S1		
Title		
SPDA1000/2000 EVB4.0		
Size	Document Number	Rev
A	USB & ROM & TEST	1.0
Date:	Thursday, December 29, 2005	Sheet 2 of 6

S1		
Title		
SPDA1000/2000 EVB4.0		
Size	Document Number	Rev
A	MIC & PHONE & LED & RESET	1.0
Date:	Thursday, December 29, 2005	Sheet 3 of 6

Title <Title>			
Size A	Document Number <Doc>		Rev 1.0
Date:	Thursday, December 29, 2005	Sheet	4 of 6

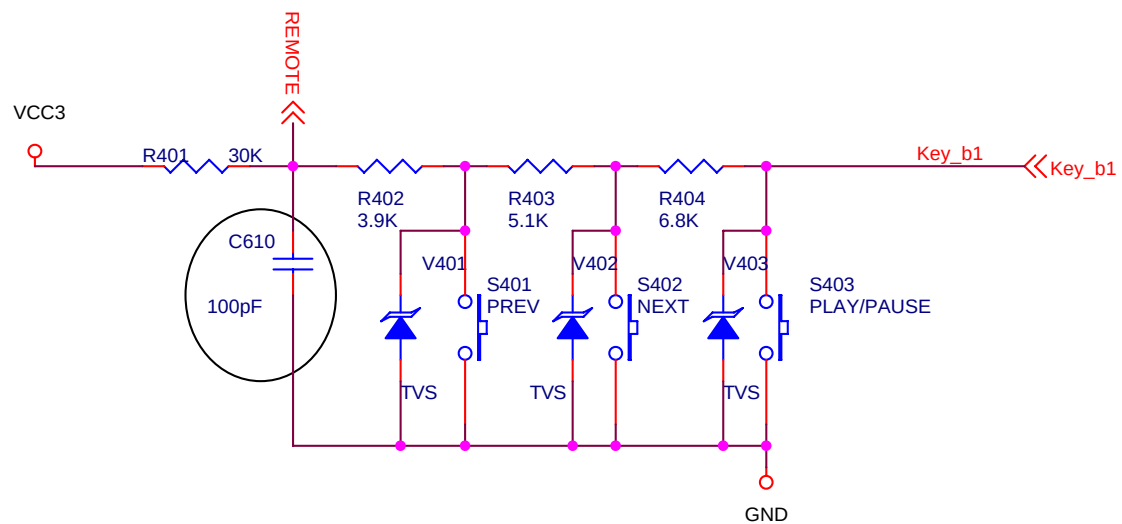
易方修改：这是FM接口考虑到HY1415、HY1417两个方案的兼容性，所以用FMD0、FMD1、FMD2、FMD3这4条数据线
